# Structure of Presentation

- Three media to be discussed tonight:
  - Ambient Air
  - Groundwater
  - Urinalysis
- In each medium, three sections:
  - What was proposed in the Tritium Sampling and Analysis Plan.
  - What Berkeley Lab does in ongoing monitoring programs.
  - Task force and community comments, and the Lab's responses.

# Berkeley Lab's Current and Proposed Tritium in Ambient Air Monitoring Network With Wind Rose from 20-meter Weather Tower Superimposed at S tack

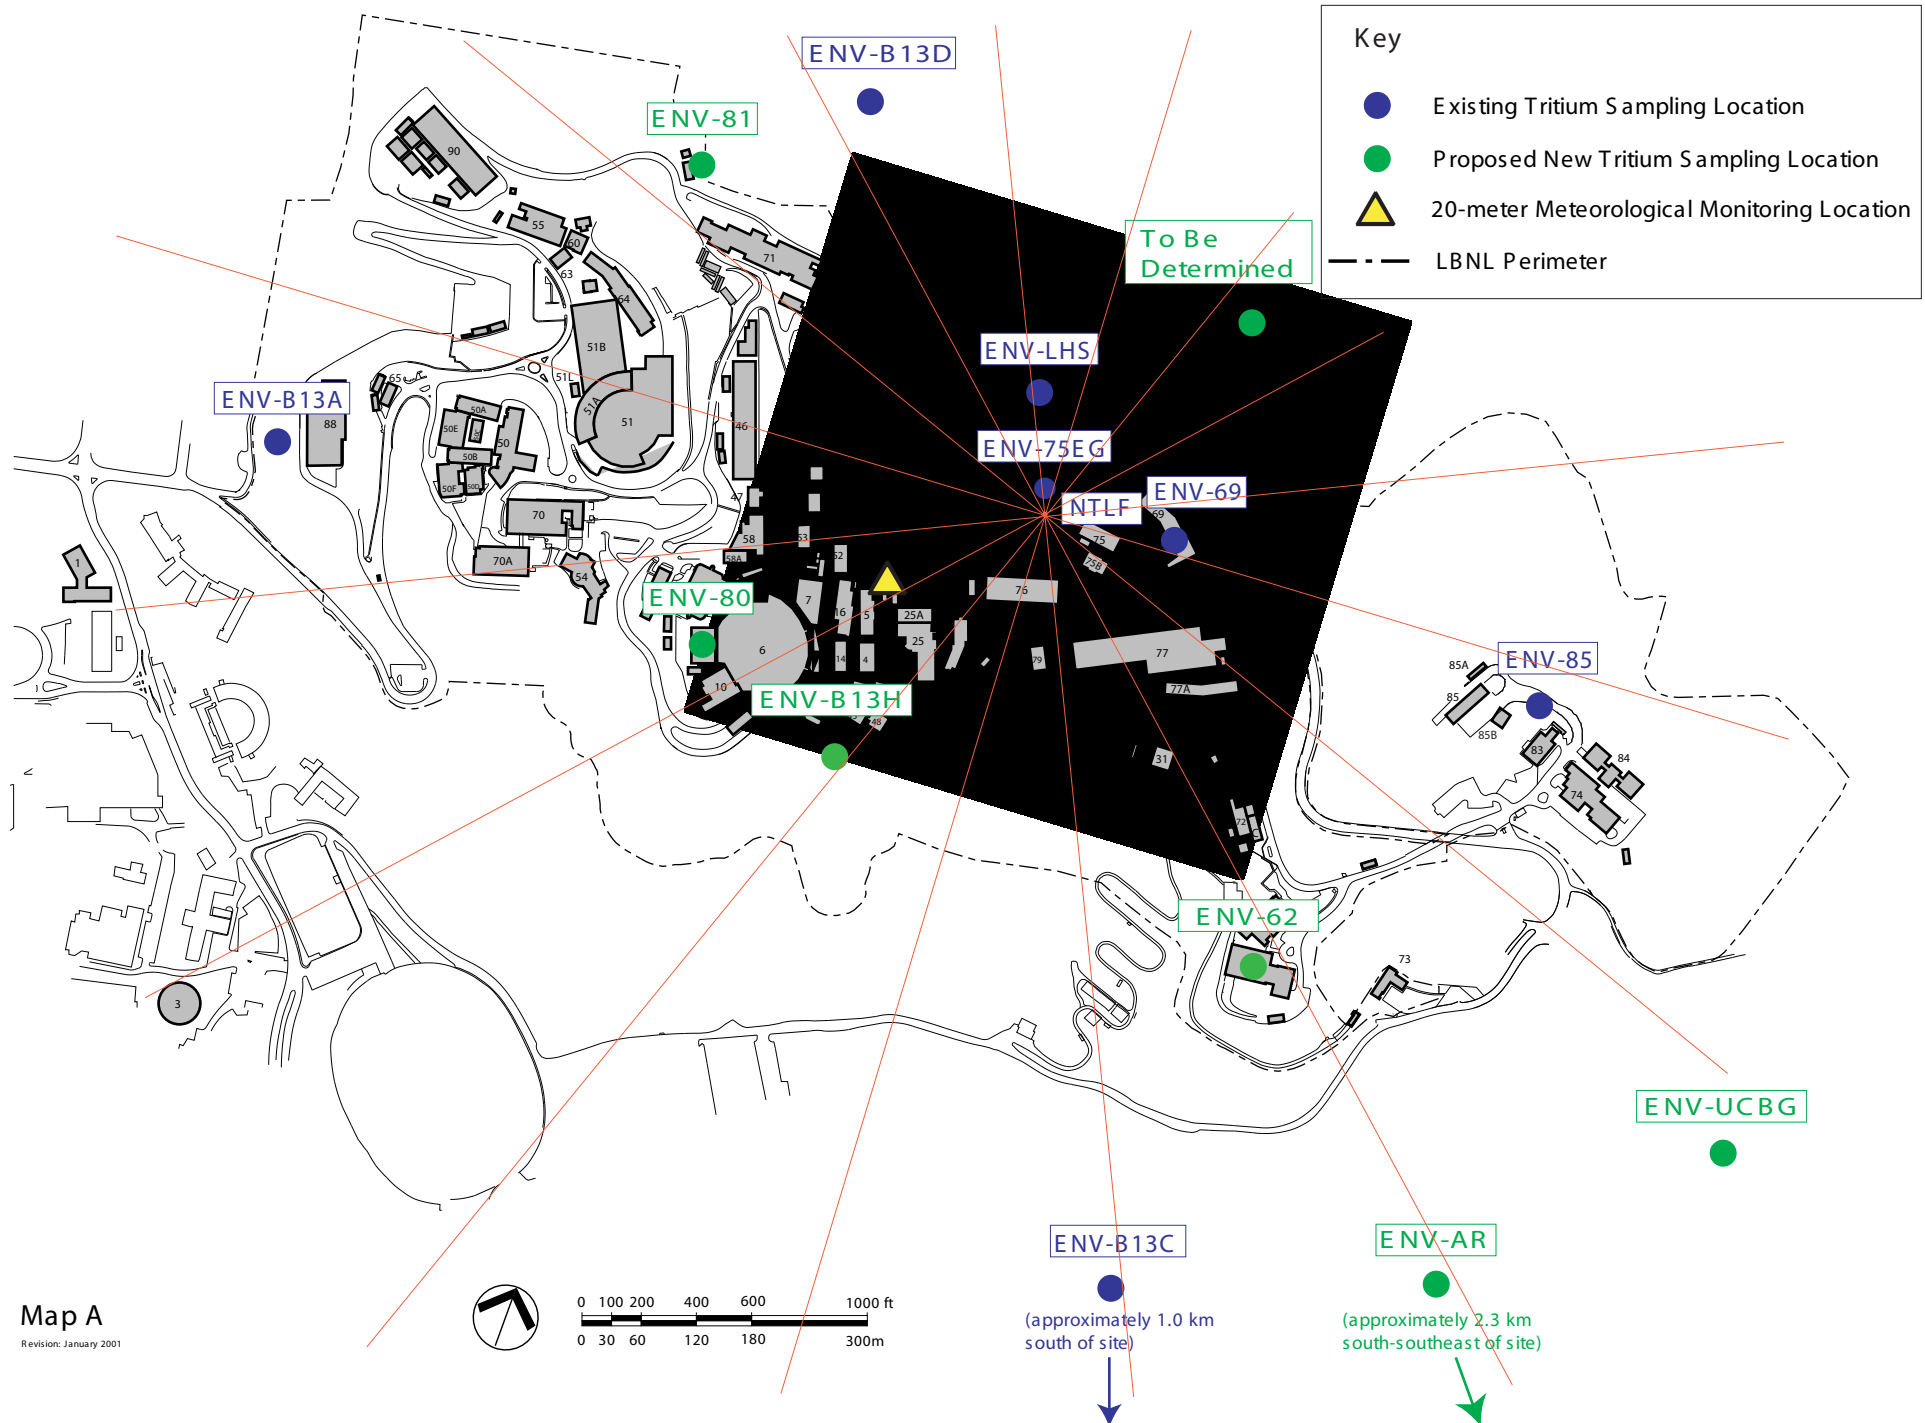
#### 3. Expand ambient air monitoring for tritium to 16 wind directions (Franke/IFEU Report, B. 1, page 19).

4. It is recommended that DOE explain the rationale for the proposed sampling locations and why a sample in the 1-2 mile distance category is not needed. (U.S. EPA letter to U.S. DOE, 8-20-99, Sample Locations 1A).
  - We have identified a site about 1.5 miles south/southeast of the NTLF stack. This is at EBMUD's Amato Reservoir, in the direction of one of the prevailing winds at the NTLF. We are planning to install this monitor to implement sampling under the TSAP.

- Berkeley Lab located its ambient air monitoring stations based on two primary considerations: 1) where people are working or living who might be affected by emissions, and 2) what the wind patterns at LBNL are like.
- As a result of a ten-fold decrease in tritium emissions, the value of some ambient air stations was determined to be negligible. As a result, in 1995, four stations (13B, 13D, 3, and Mathematical Sciences Research Institute) were eliminated.
- The Lab will add 5 additional ambient air sites for TSAP sampling to the existing network. The total number of sites will be 14, including buildings 13H, 80, 81, UCB's Mathematical Sciences Research Institute, and building 62.
